Public Comments

For the Draft Report of the Ad Hoc Advisory Committee on South Flow Arrivals

Received after 4/27/18

Figure 2.

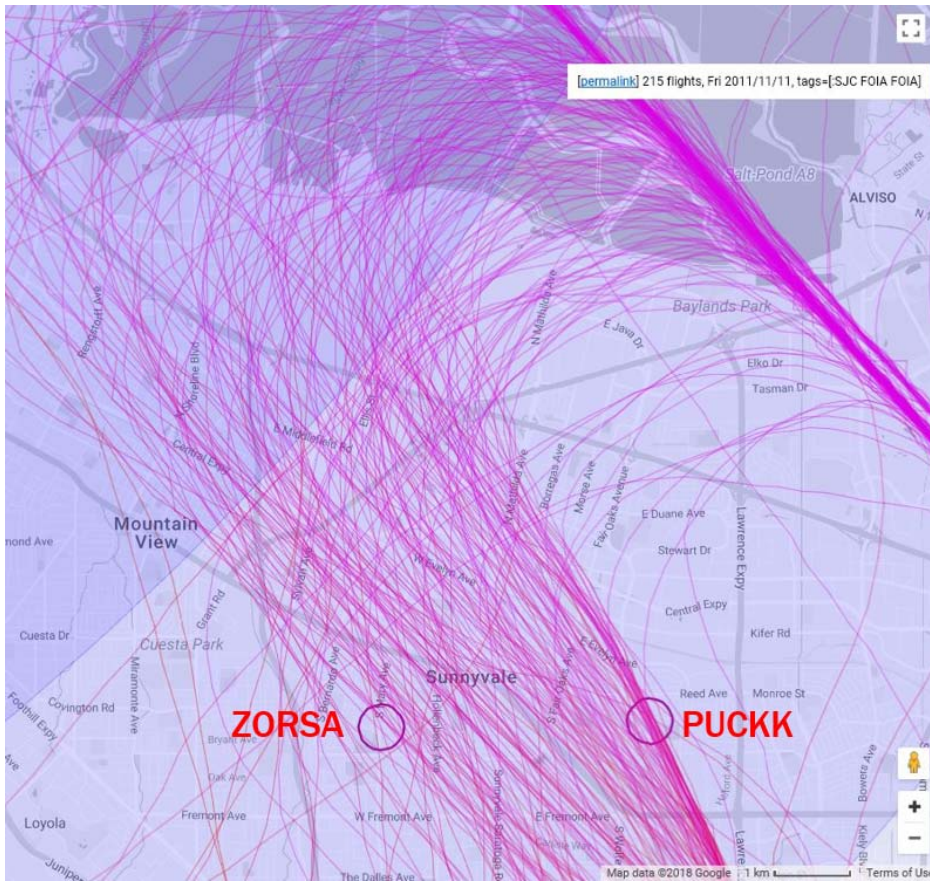
Commented [RH10]: HIGH: The FAA has, at times, described the 'rails' differently than the Committee has, so it's important to be clear. If it's inappropriate to embed a picture, consider stating, "please see Appendix, *Community Recommendations for the Ad Hoc Advisory Committee* - 4/24/18, Figure 2"

Commented [RH13]: HIGH: We owe it to ourselves to be clear about what we want to see. If we aren't clear, we can't be disappointed if there is no progress toward the change we seek. These statements are as important for the 'long game' as anything.

airplanes over fixed rails should be sought (figure 1); noise should revert to where it was prior to 2012, in the same geographic proportions (figure 2). (Using Please see also the success criteria listed below.)

Figure XX

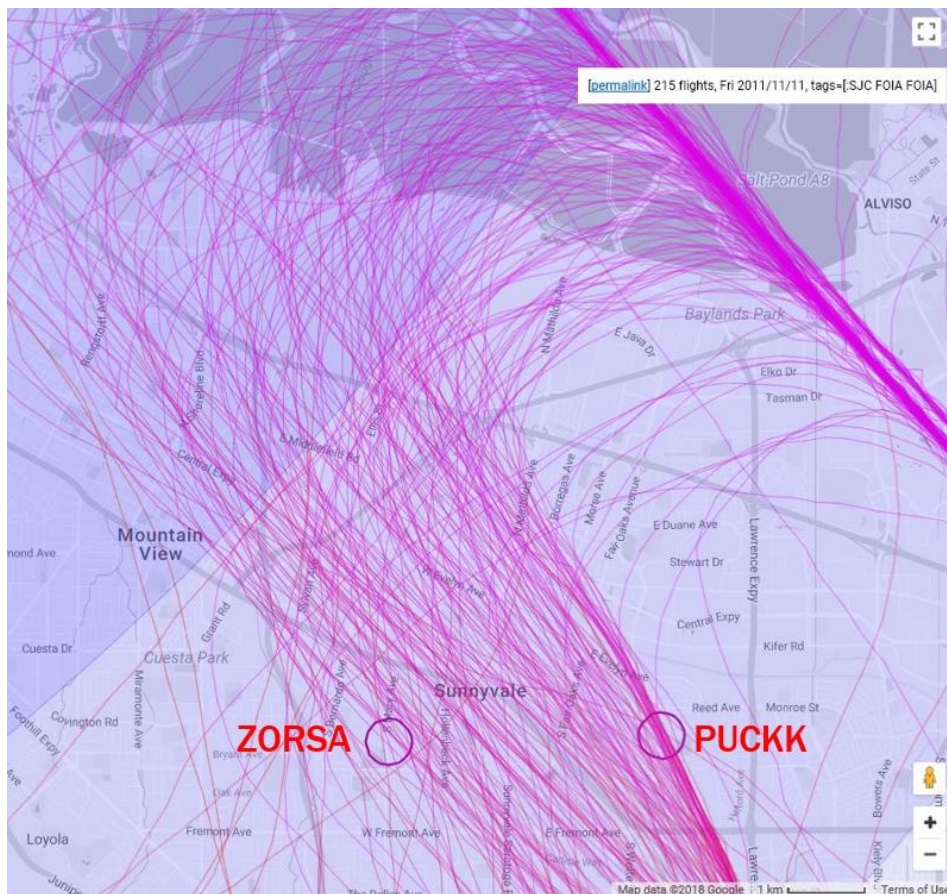
Commented [JT2]: Would be helpful to have a picture of the historical dispersion in this section, so the historical dispersion level is clear to all parties.

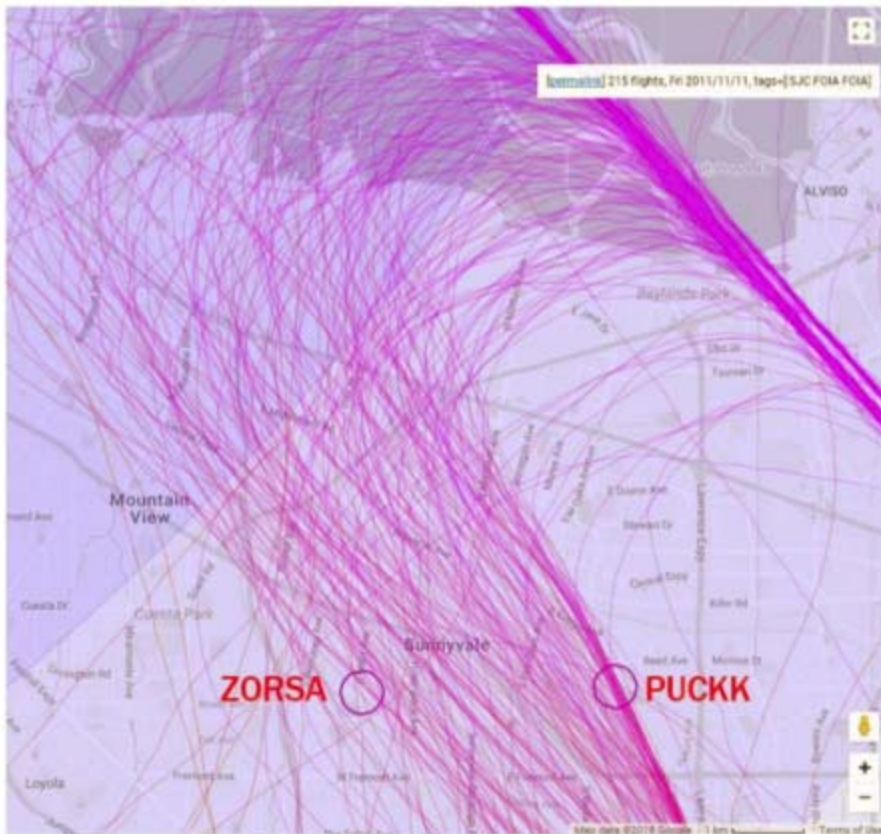
The picture below shows today's situation: The yellow dot shows our house. A San Jose flight path has been moved pretty much on top of our back yard. There are also plenty of schools and day care locations around. On South Flow days, we now get low flying planes every few minutes. If we sit outside, we cannot converse while they fly by. And because they are so frequent, we are basically waiting for the next one. South Flow days are miserable outside, and not very pleasant inside either. I can only imagine how bad it is for people directly under the rail. With the traffic growth expected in San Jose, this situation will just get worse and basically prevent e.g. school activities outside.

We must get back to dispersed traffic. It's a lot less impacting to the community than the hyper concentration on top of a narrow slice.

Figure 1. Dispersion prior to 2012. (1/11/11)

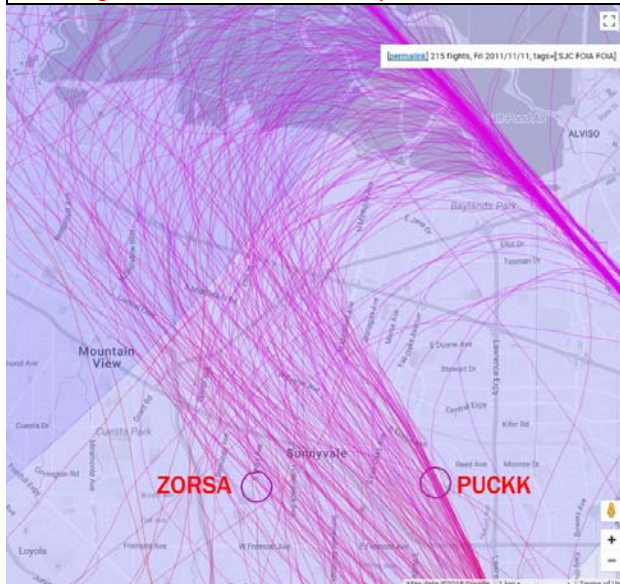
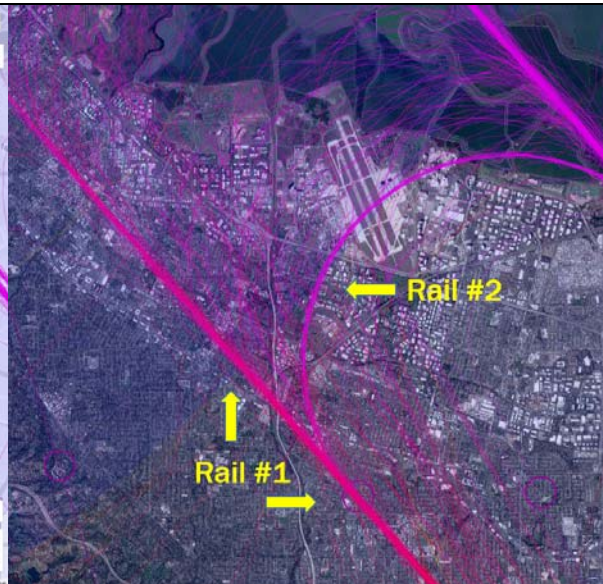
Prior to the implementation of NextGen, aircraft were dispersed over a broader area of air space thereby limiting concentrated negative effects on residents and neighborhoods. *See the map in Figure 1 below showing the dispersion of aircraft between the ZORSA and PUCK waypoints prior to 2012.* A dramatic increase in noise complaints resulted from the implementation of NextGen. NextGen, a program which switched a radar-based approach to a GPS approach, has resulted in the use of Required Navigation Performance (RNP) and Optimal Profile Descent (OPD). These tools and procedures create a concentration of flight paths *or “rails”* over specific neighborhoods and homes, which now bear the brunt of ground effect noise. *See the map in Figure 2 below showing the two rails that developed with the FAA’s move to NextGen.*

See Attachments to this email for Figure 1. Dispersion prior to 2012. (1/11/11) and Figure 2. Two rails after Nextgen (3/10/16)

Figure 1. Dispersion prior to 2012. (11/11/2011)
ZORSA is ~2nm (2.3 miles) west of PUCKK

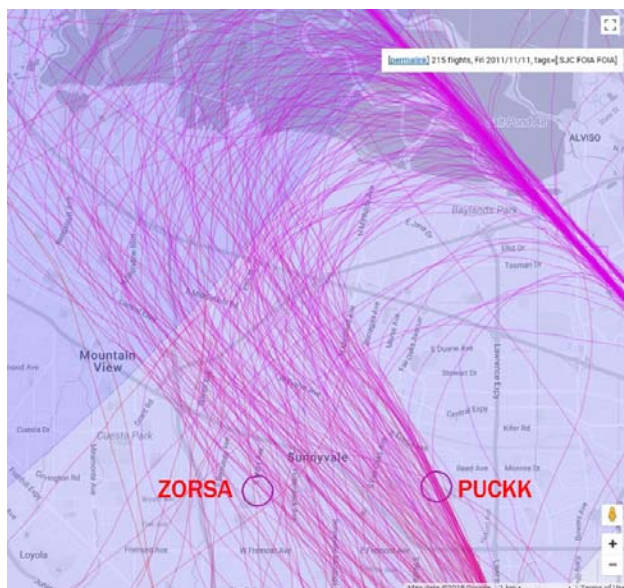
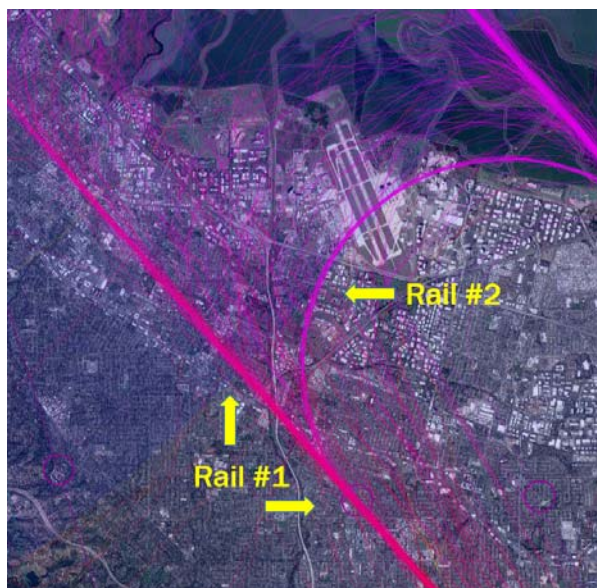
- **Add a diagram that shows the dispersion we previously had and seek to return to.**
 - **Add:** Figure 1. Suggested location: after first paragraph, page 8. The dispersion of November 11, 2011 describes historical patterns that existed for many years. A picture is worth 1000 words, and it is important for this picture to be included in the report so that all parties are clear on what was lost and what we would ideally return to. It is too easy to be confused about what is sought otherwise. This is also too important to be left to an appendix.

- **Add:** "see figure 1". Suggested location: end of first sentence, page 8.
- **Clearly acknowledge the two rails. The report only acknowledges one!**

- **Add** a diagram (figure 2) showing the two rails. Suggested location: after first paragraph, page 8. The current report does not reference the other rail and at the last meeting Mr. diBernardo seemed not to acknowledge it either. Proof that the ambiguity is too important to be left to the appendix!

Directionally, the Committee recommends that the FAA drive toward: 1) alternatives to routing airplanes over fixed rails; 2) reversion to ground noise patterns prior to 2012, in the same geographic proportions (figure 1).
